Suspected root cause**①GND PLATE too thin**

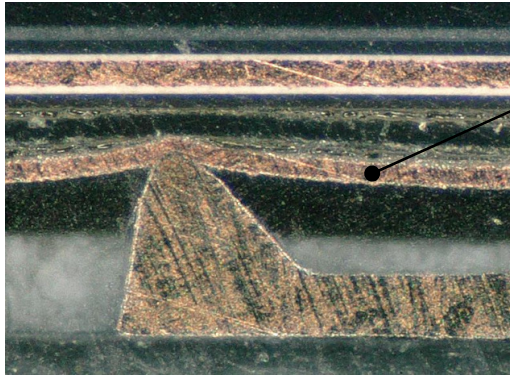
②Additonal extra force applied when inserting FFC

When inserting FFC, given additional downward force applied directly on FFC(see above), the extra pressure could cause the pierced-thru

■section view

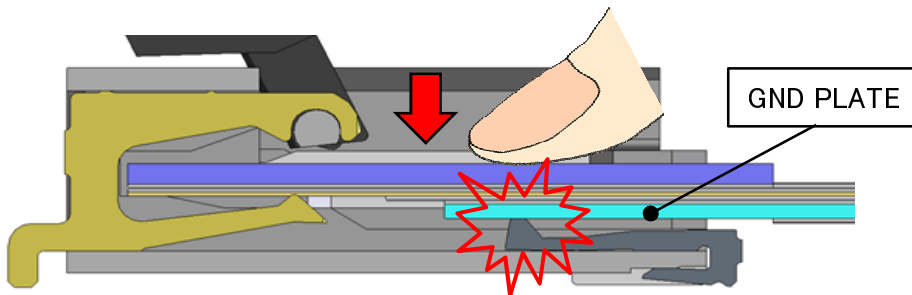
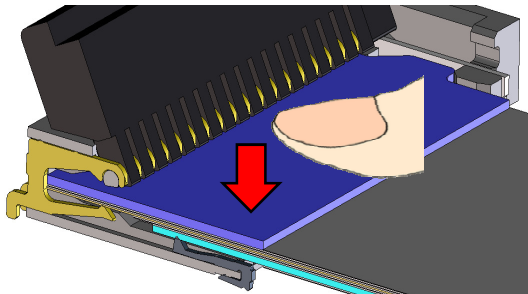
GND PLATE thickness		unit: μm
Moter board side	44	
AMC board side	43

GND PLATE thickness		unit: μm
HRS recommendation evaluating use	72

The GND plate's thickness is only 60% of HRS recommendation.
